1107.1600 MSW Sub D Land

Subject: Water Quality Monitoring Plan
Additional Surface Water Sampling Location
Buncombe County Subtitle D Landfill Cell 6

Subject: Monitoring Well Installation and Initial Sampling Report
Revised Figure 1
Buncombe County Subtitle D Landfill Cell 6

RE: Review Of The Design Hydrogeologic Report Of The
Construction Plan Application For The Proposed Cells 1-3
Of The Buncombe County MSWLF Landfill

*Detail for revised sampling point
for alternative monitoring system
Cell 3 -Buncombe Cty*

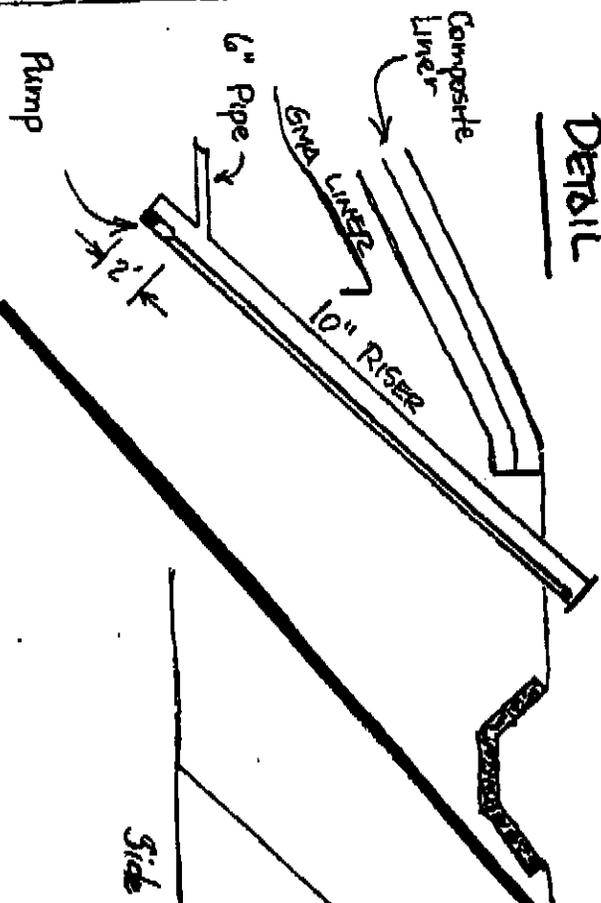
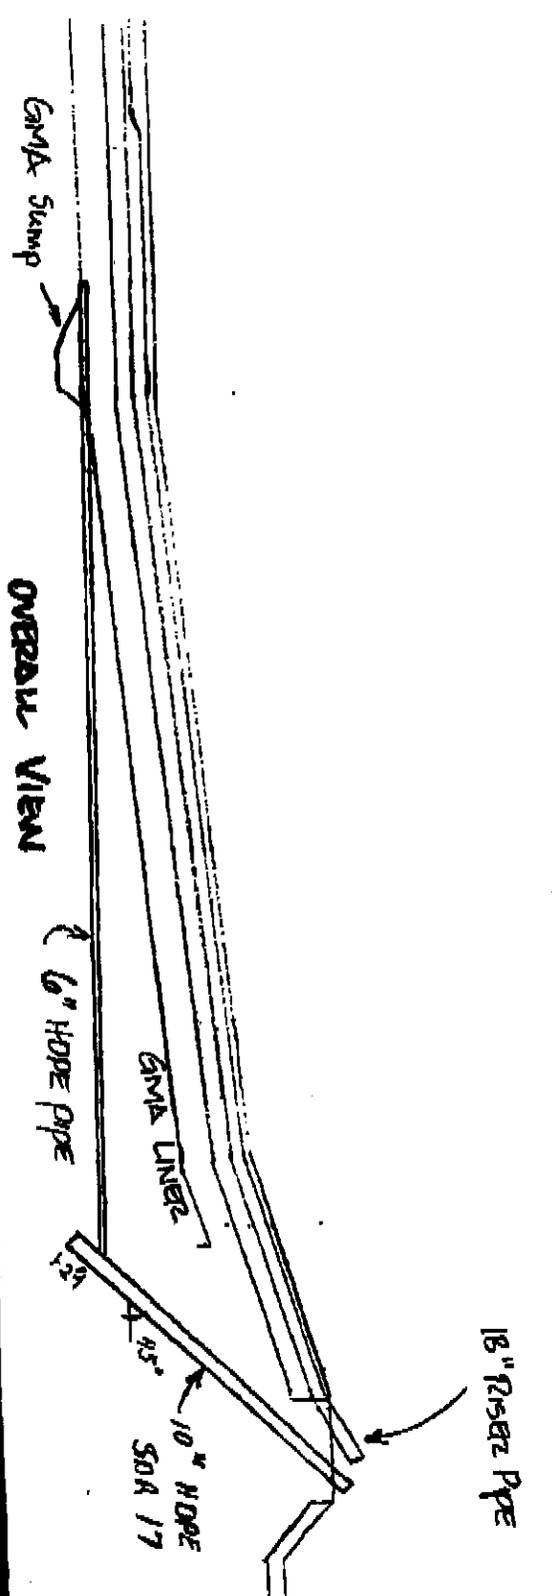
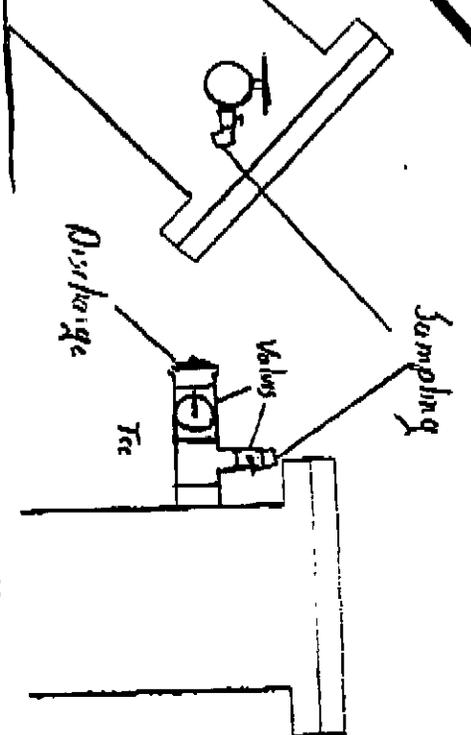
BUNCOMBE CO. LANDFILL (VALUE ENGINEERING)

DETAIL

FITTING DETAIL
